Project:	1960 - Elm Grove, Trowbridge		
Technical Note:	Technical Note - Phase 1 Basin		
Date:	28/01/2026	Originator:	David WJ Patterson

Introduction

JRC were requested to provide details and supporting information relating to the planning updates to the FWPS and Basin adjustments in the Phase 1 development area of the Elm Grove, Trowbridge site.

Proposed Revised Arrangement

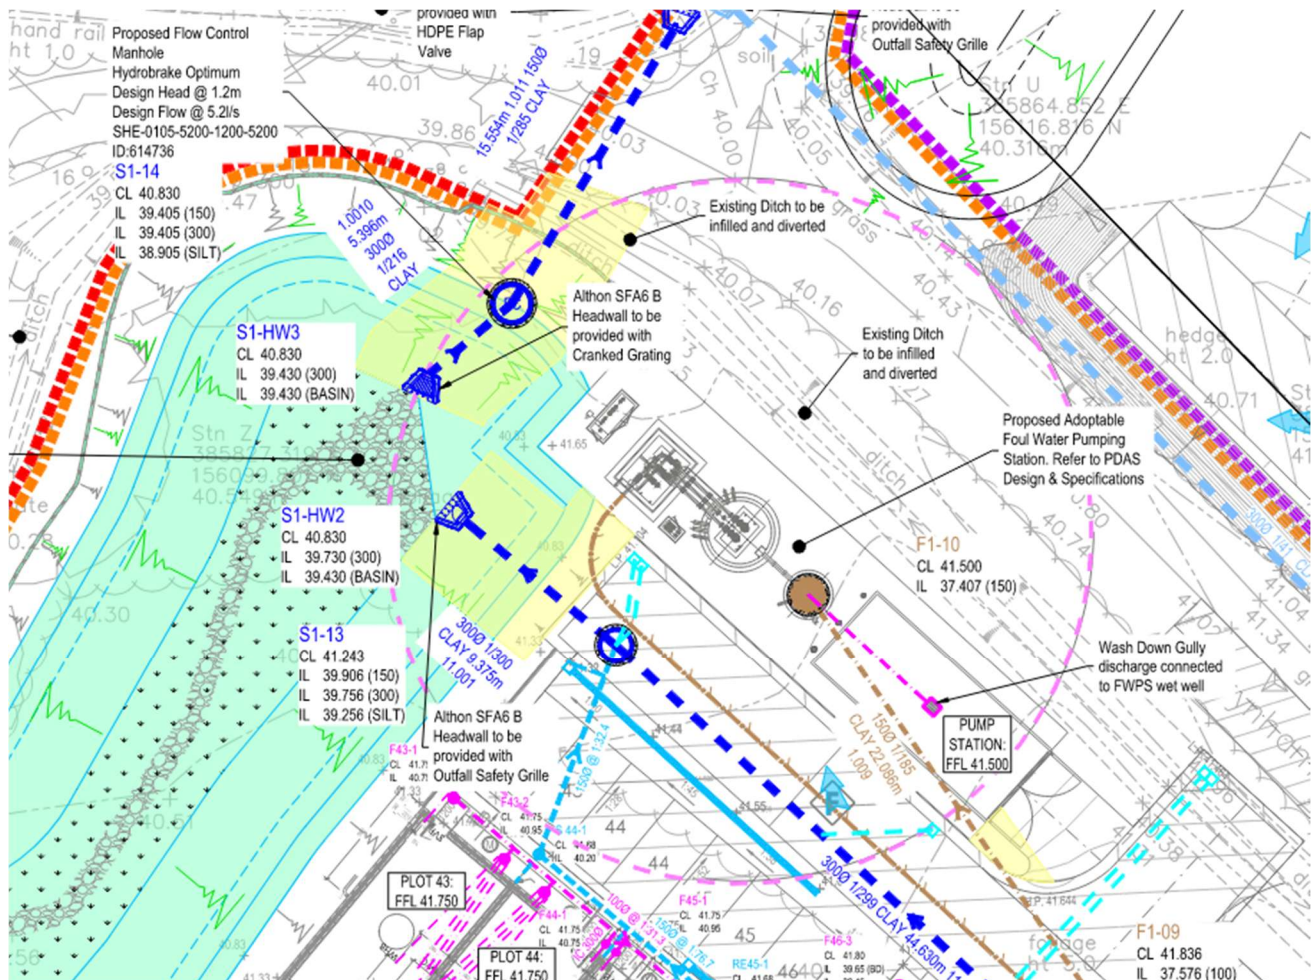
Following additional review of the proposed site layout and key constraints it was required that the FWPS needed to be reconfigured. In consultation with ICOSA / LastMile the arrangement was adjusted to a single "in line system" which moved the compound area away from the boundary with Drynham Lane.

The result of the change in configuration of the FWPS is that a corner section of the Phase 1 Basin will be needed to be adjusted and reprofiled.

DRAINAGE LAYOUT PHASE 1 SHEET 2

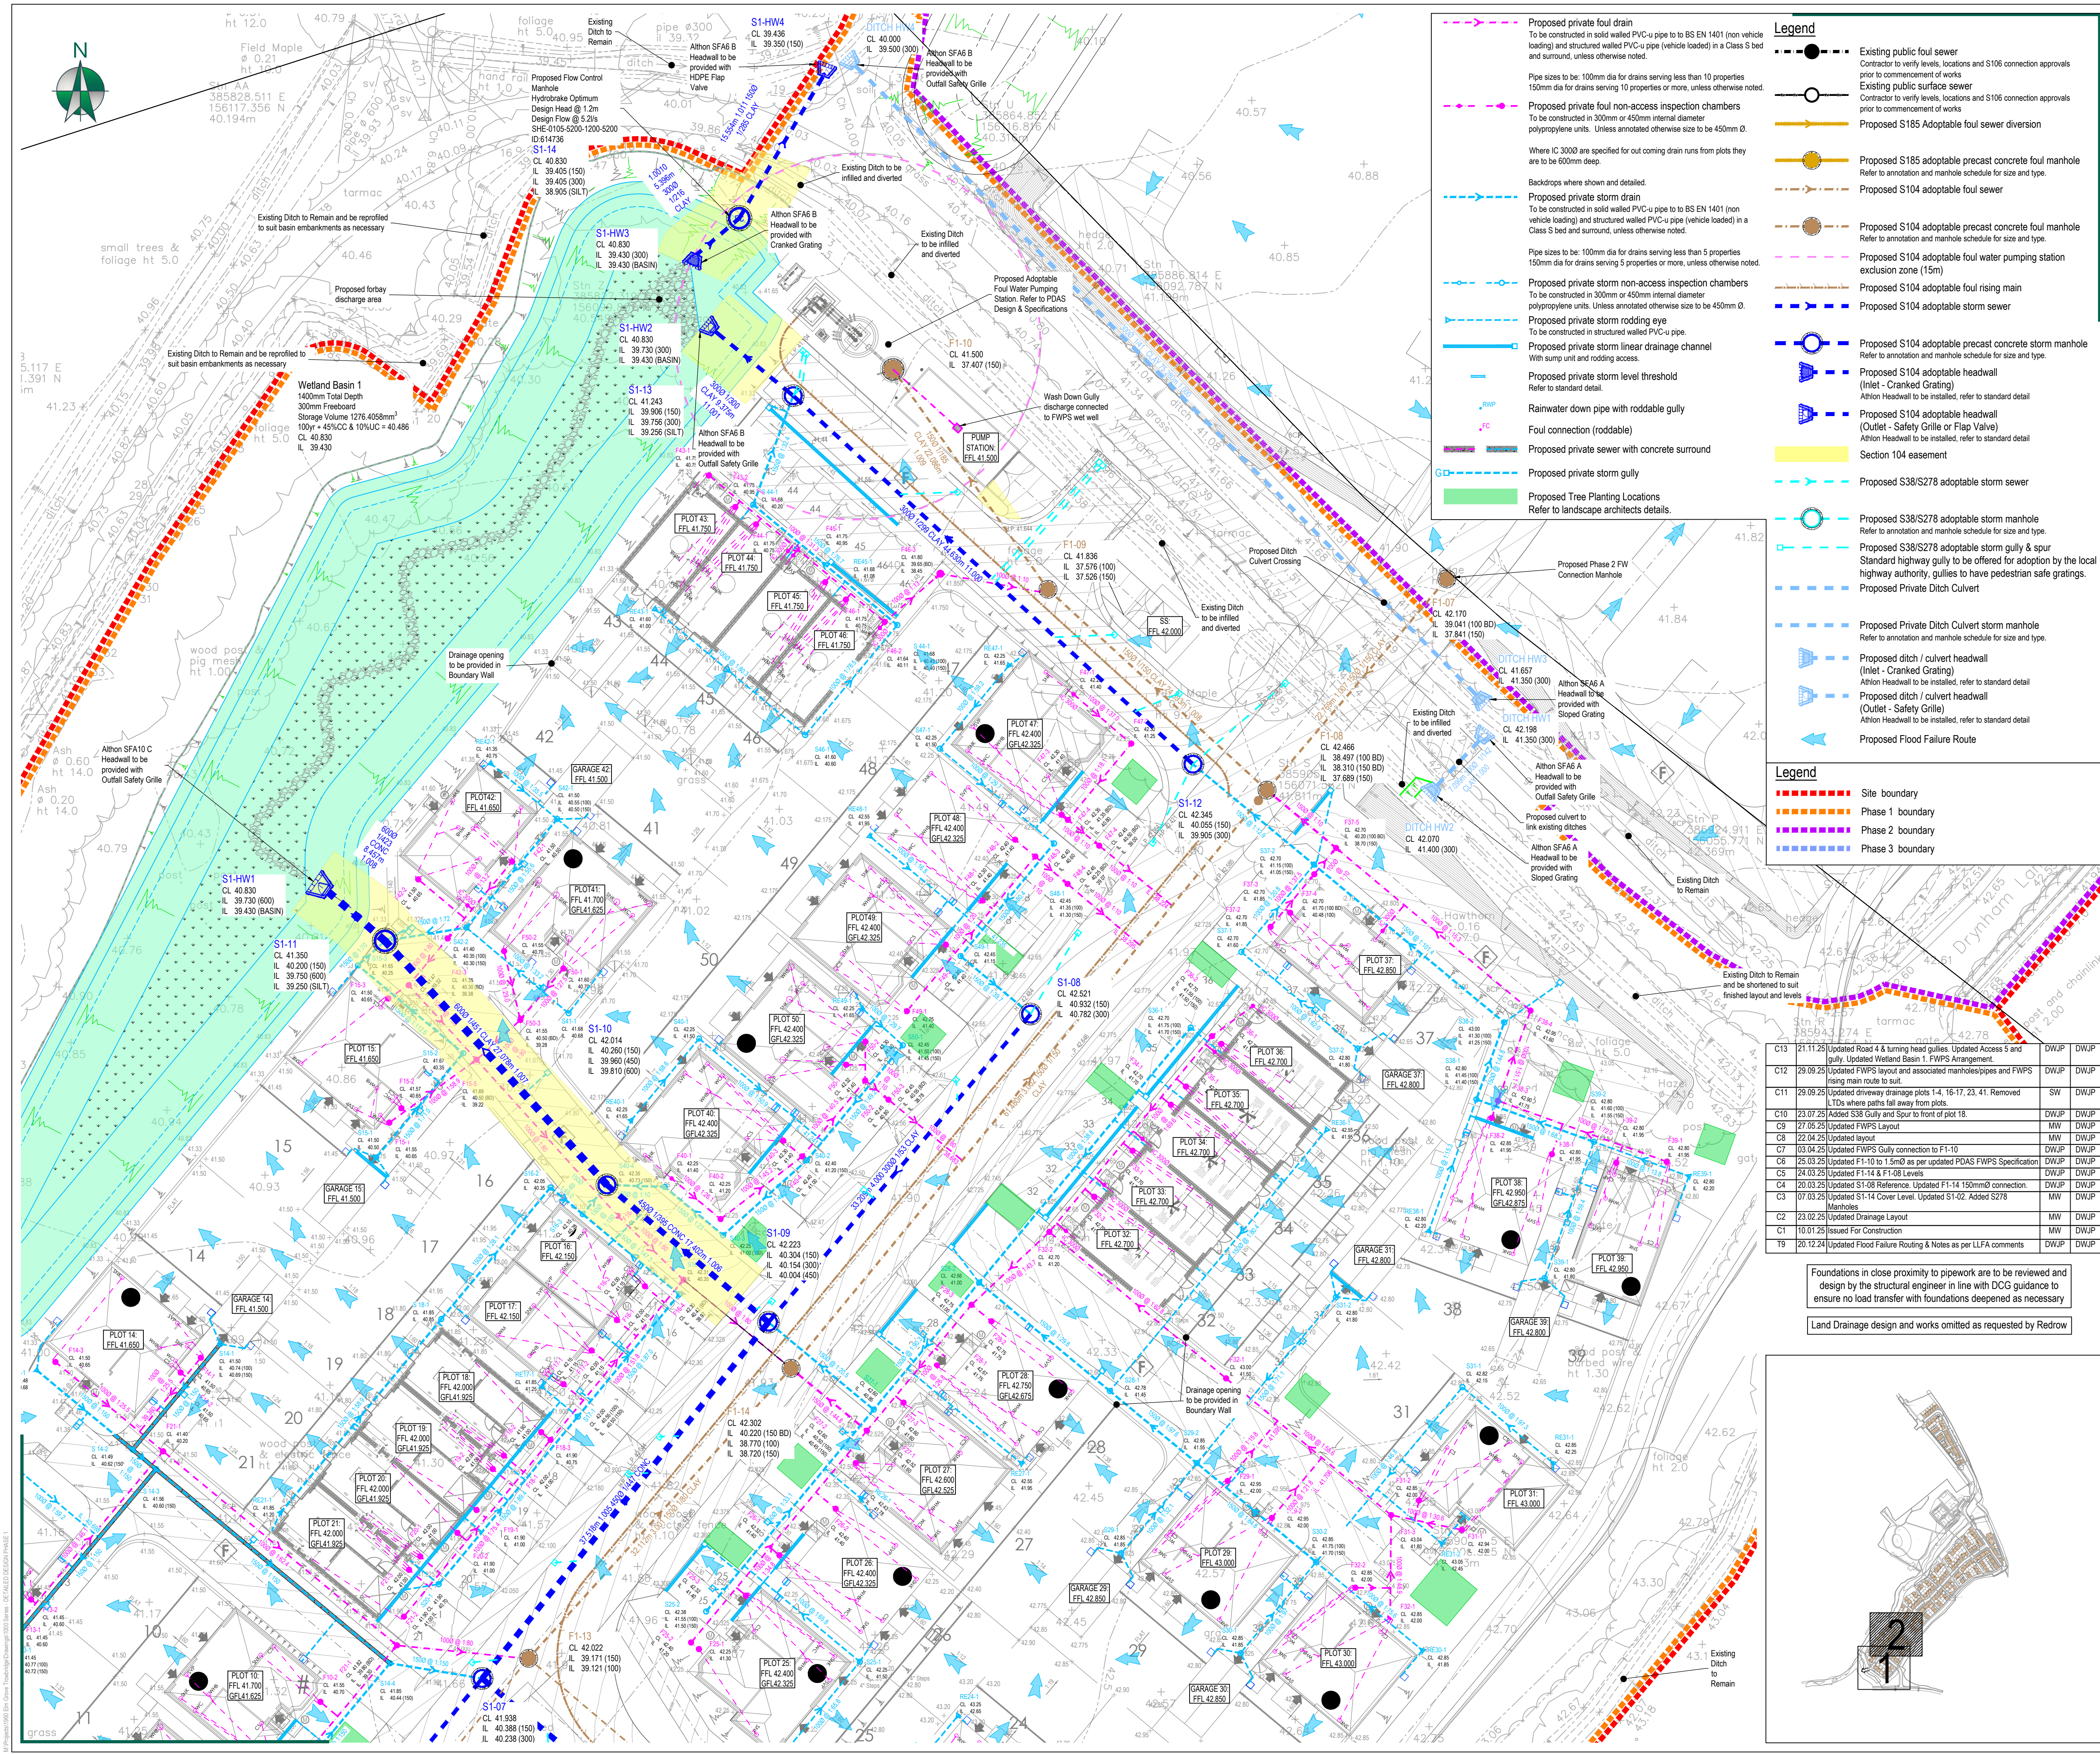
The changes in the Phase 1 Basin have been modelled and hydraulically reviewed. The updated calculations are appended to this Technical Note for reference and show that the basin remains in compliance with the critical design storms up to the 1 in 100 + 40% with a maintained peak discharge rate of 5.2l/s all in line with the original Flood Risk Assessment and Drainage Strategy.

The FWPS and Phase 1 Basin arrangement and updates have already been Technically Approved by ICOSA/LastMile for adoption under a S104 agreement.
